**FINAL PLAT APPLICATION**

PROPERTY INFORMATION			
Project/Property Address: <b>Buckles Court North</b>		Proposed Subdivision Name: <b>Crescent at Central Park Section 2</b>	
Parcel #: <b>025-013773-00</b>	Zoning: (see <a href="#">Map</a> ) <b>SCPD</b>	Acreage:	<b>13.336</b>

Subject: Crescent at Central Park Section 2 Final Plat  
City of Gahanna, Franklin County, Ohio  
CEC Project 314-902

RE: Project Buckles Court North Final Plat

**PLAT**

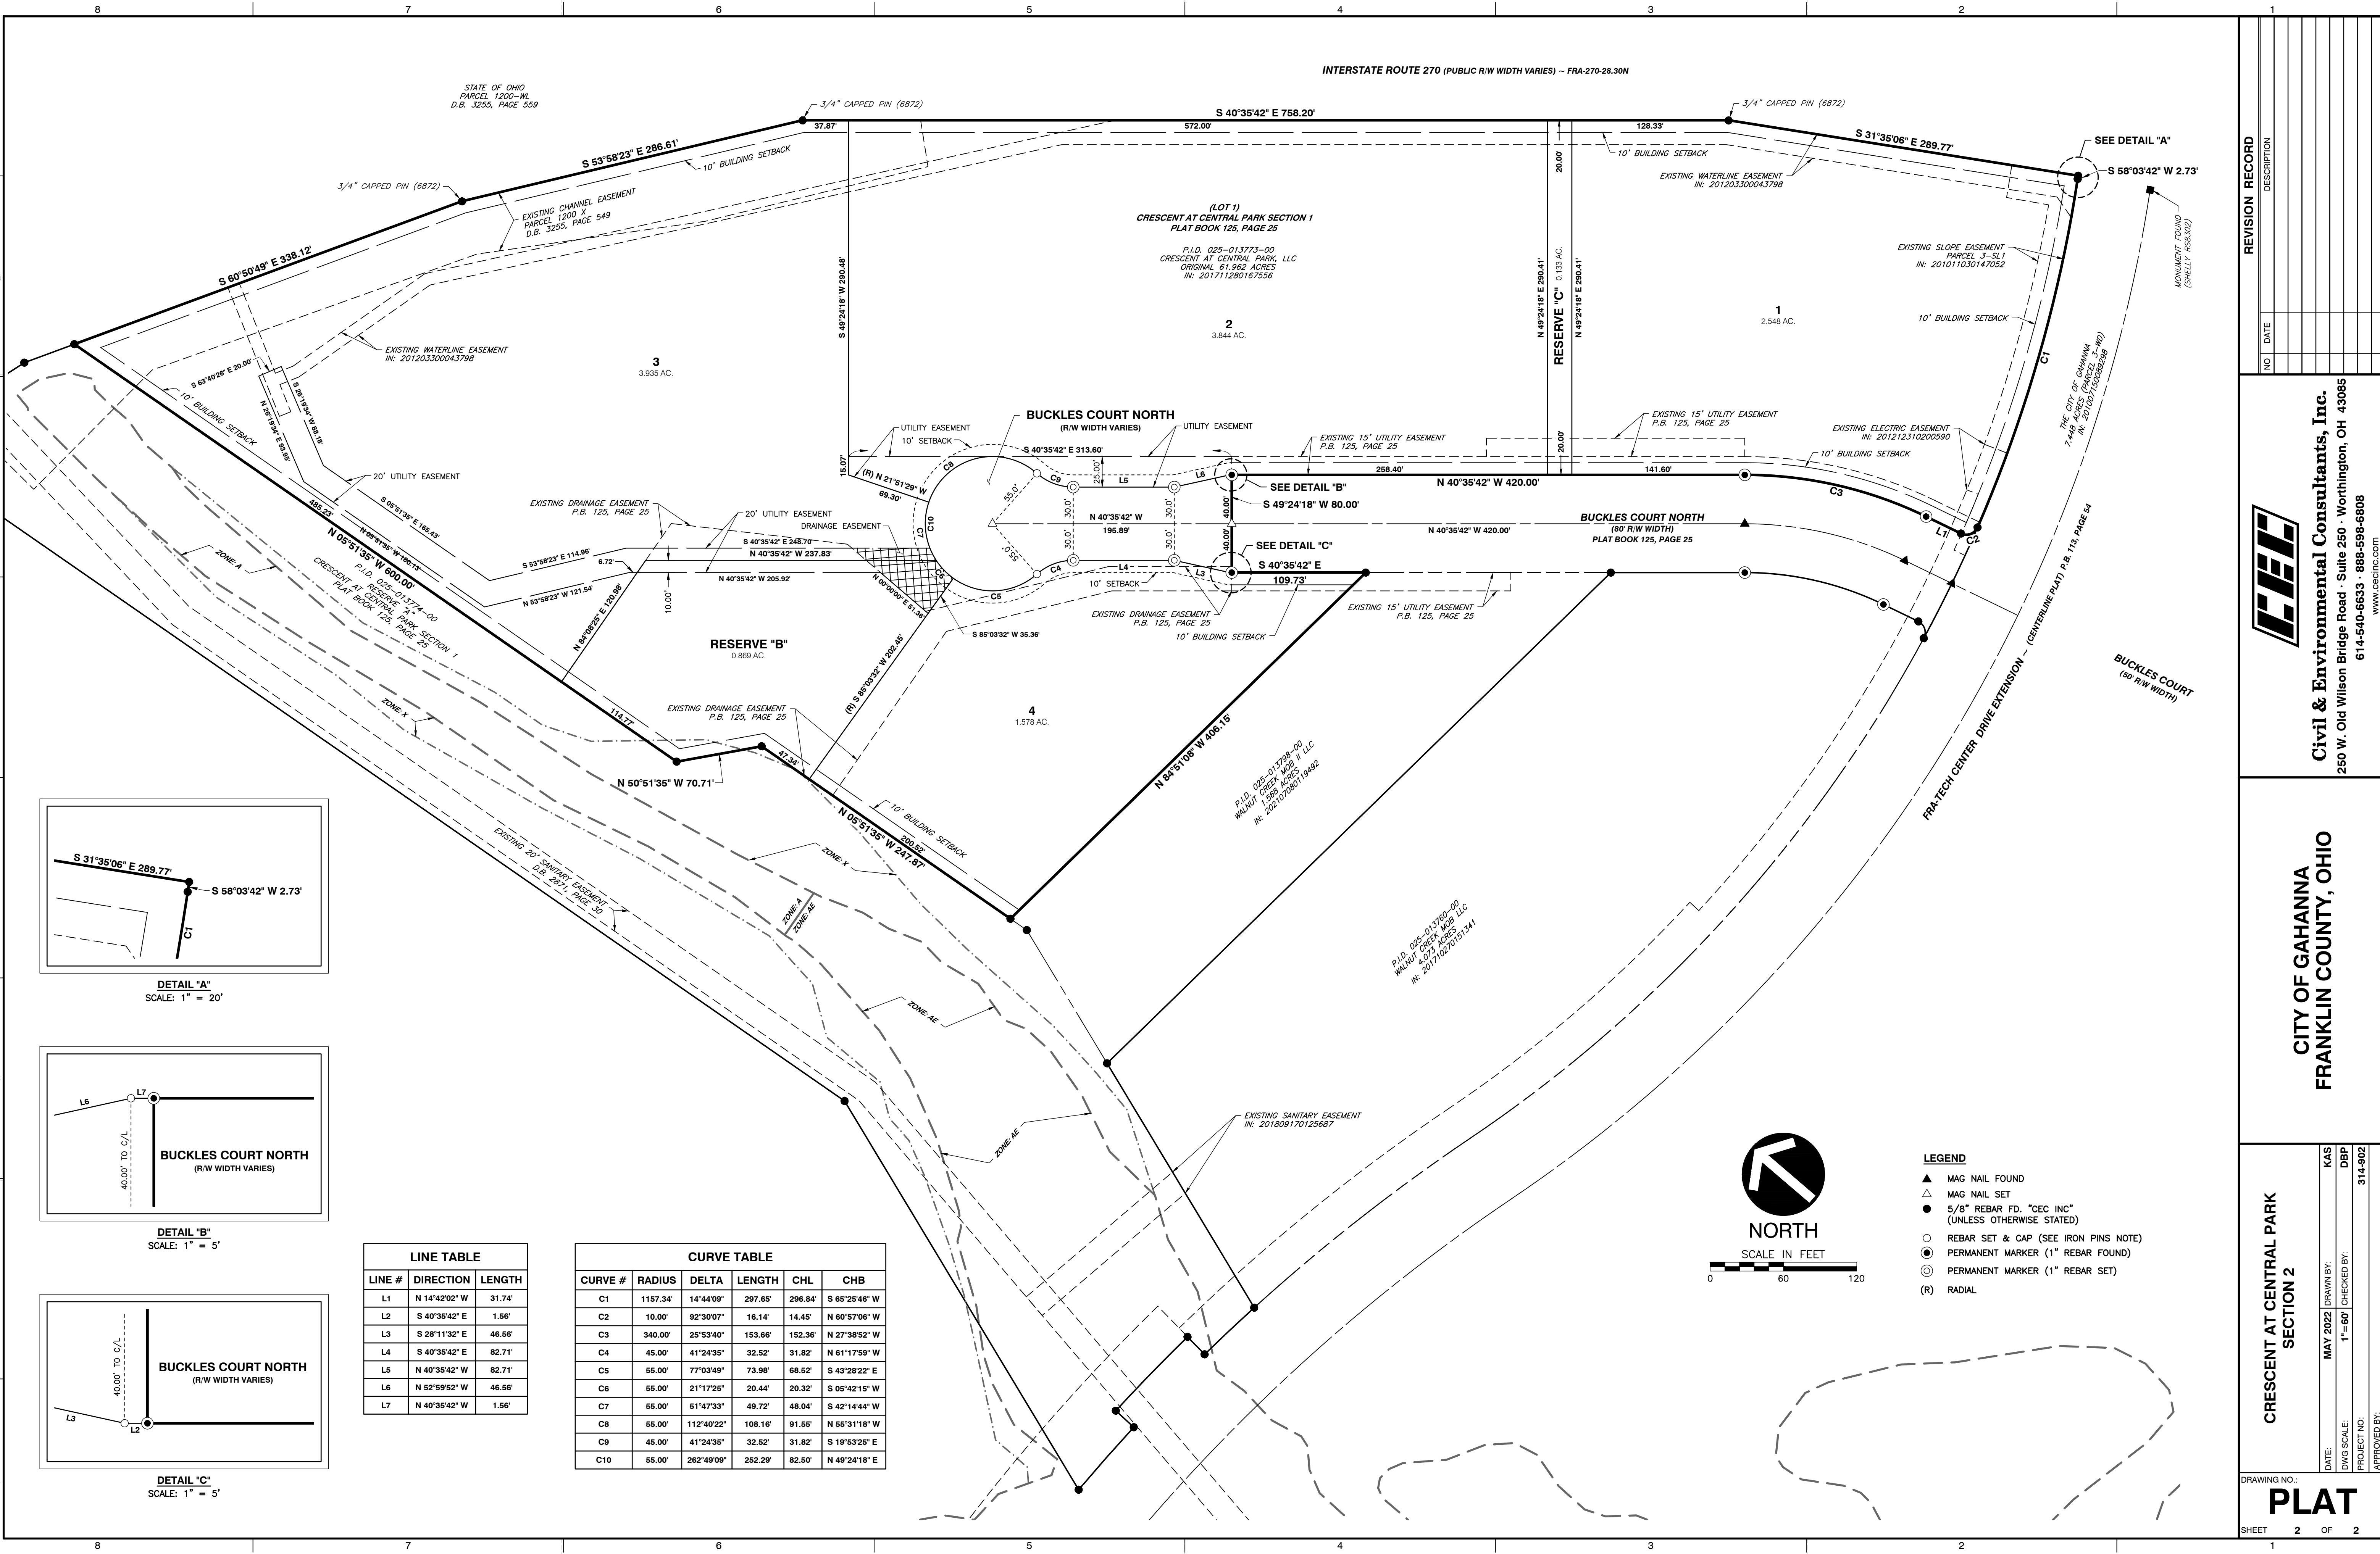
1. Note B on the plat states that reserves A and B will be owned by the City. Reserve A doesn't appear to be land included in this plat. Reserve A was included in the 2018 final plat and was to be owned by the property owner and maintained as open space. The City has discussed, and we are not interested in ownership of the reserve areas. Please revise accordingly.

6. Please correct the "Floodplain Designation" note to indicate that only Flood Zone X is located on this subdivision, rather than "Flood Zones: Zone "X" and "X"".

7. Add a label indicating that the area northeast of the cul-de-sac bulb is a utility easement.

8. Any overland flood routing of drainage that exceeds the capacity of storm sewers between the public right of way into Reserve B must occur within a drainage easement. Where does that overland routing occur? Add any easements necessary to contain it.

9. Add a Note "D" to the Plat to the effect of "In accordance with Gahanna Codified Ordinance 1193.05, The lands within the Crescent at Central Park Section 2 have been granted a waiver from the stormwater quantity control requirements of Gahanna Codified Ordinance 1193.06(a) and 1193.06(b)."

10. Note that the proposed cul-de-sac geometry does not meet City of Columbus standard drawing 2156, but is acceptable as shown. (Informational Comment)

Note B updated to remove ownership by the City.

Note "B" revised.

The Floodplain designation has been updated.

Label has been added.

A drainage easement has been added within the utility easement.

Note has been added.

STREET TREE PLAN	
DATE:	MAY 2022
DRAWN BY:	HKS
DWG SCALE:	1"=50'
CHECKED BY:	DJR
PROJECT NO.:	314-902
APPROVED BY:	DRAFT

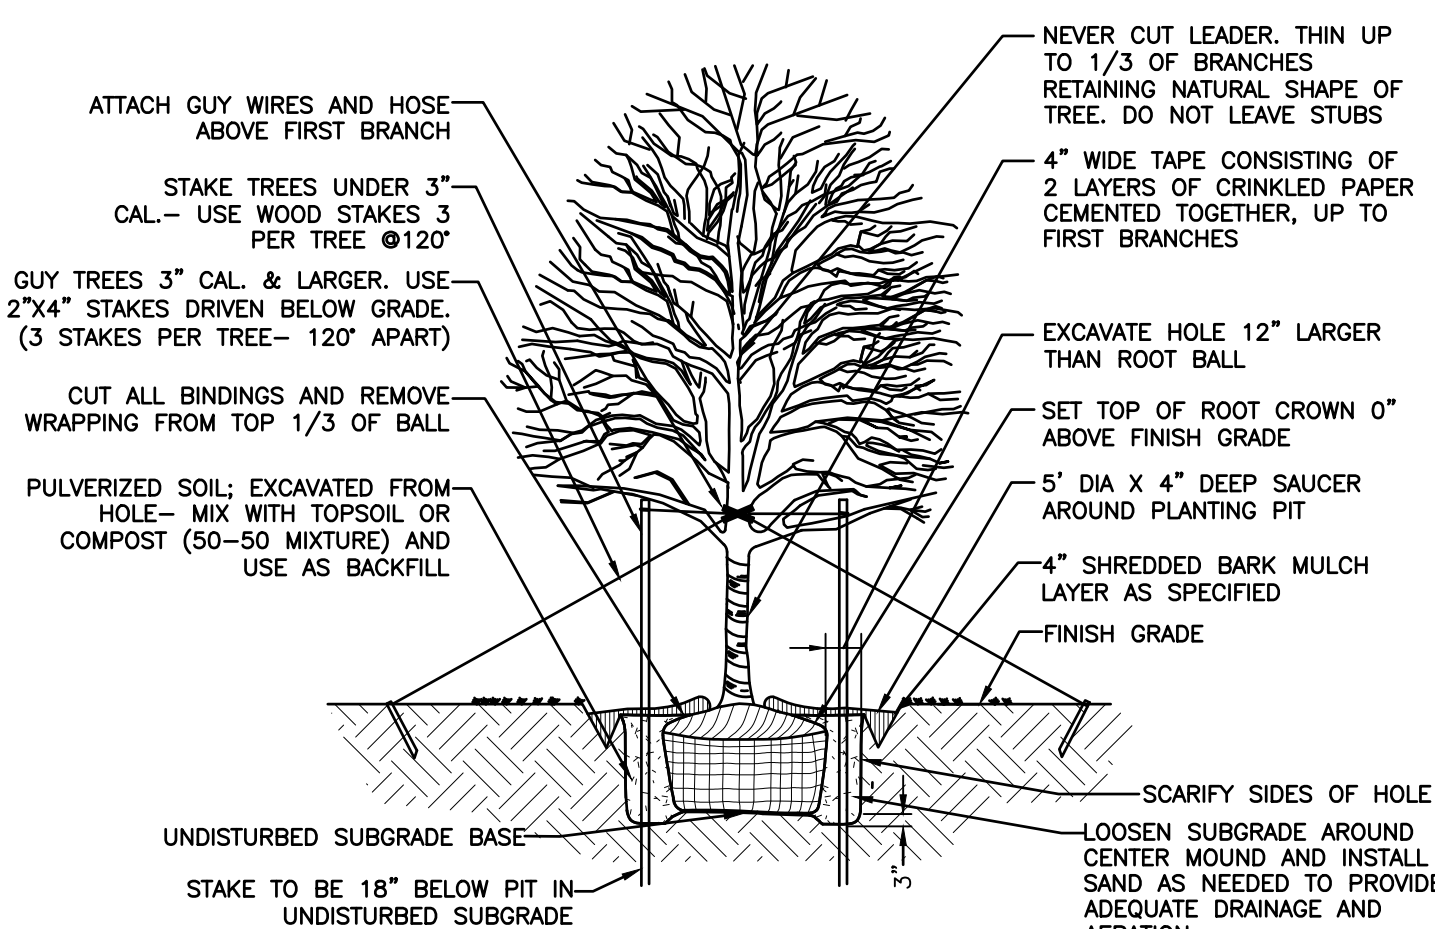
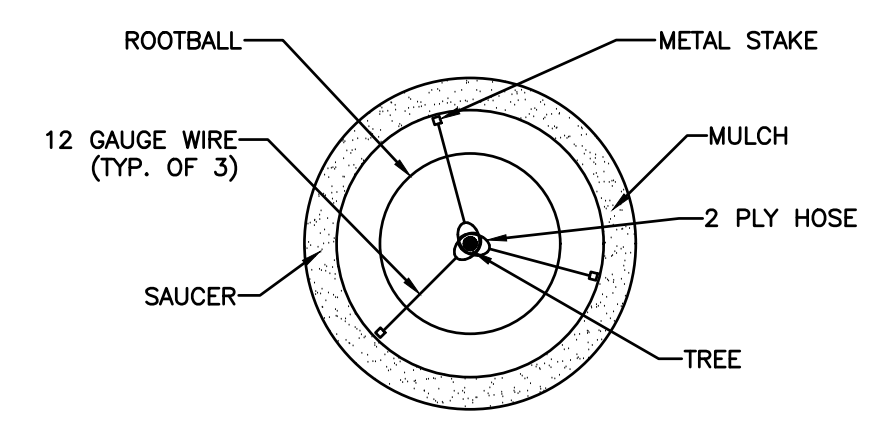
5. I believe street tree plans need to be reviewed by the Landscape Board. Tree spacing should be within the guidelines set by code 913. Planting details need to be adjusted to show root flare even with finished grade instead of top of root crown 4" above finish grade. Mulch should be pulled away from the trunks of trees. Top 1/3 of burlap and metal basket should be removed from the root ball at a minimum.

2. I believe street tree plans need to be reviewed by the Landscape Board. Tree spacing should be within the guidelines set by code 913. Planting details need to be adjusted to show root flare even with finished grade instead of top of root crown 4" above finish grade. Mulch should be pulled away from the trunks of trees. Top 1/3 of burlap and metal basket should be removed from the root ball at a minimum.
3. Species of tree does not appear to be included in the included street tree plans. This information should be included.

Street tree plan updated and attached for review.
